# Inspection of Automatic Sprinkler System

BW3 Linde & Wiemann East London  
Industrial Development Zone

UNC8477

Photo 9

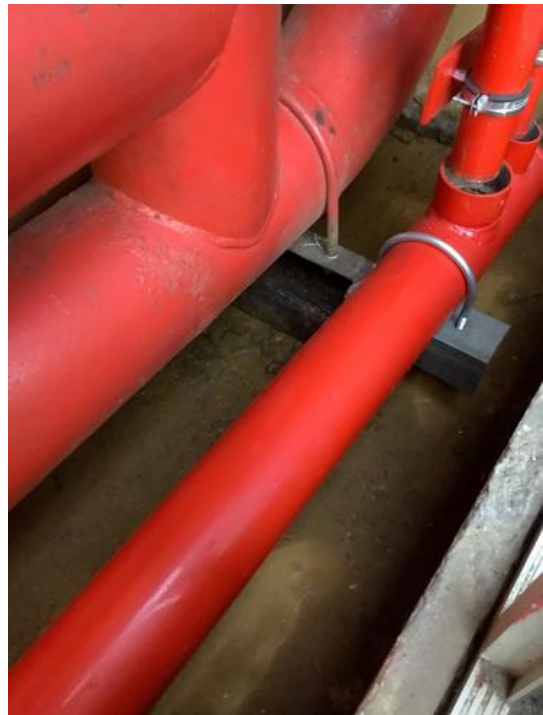
7.9 Are the Installation Control Valves Housed within an Approved Valve Cabinet	Yes
Sprinkler protection is required within the valve cabinet	<input checked="" type="checkbox"/>
7.10 Flow Switch Installed Correctly	Yes
7.11 Manifold Correctly Supported	No

The valve manifold must be adequately supported.

Photo 18

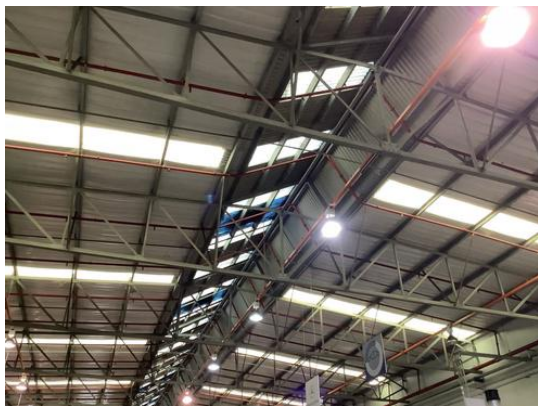
**Sprinkler heads must be correctly aligned.**

Low bay roof above workshop
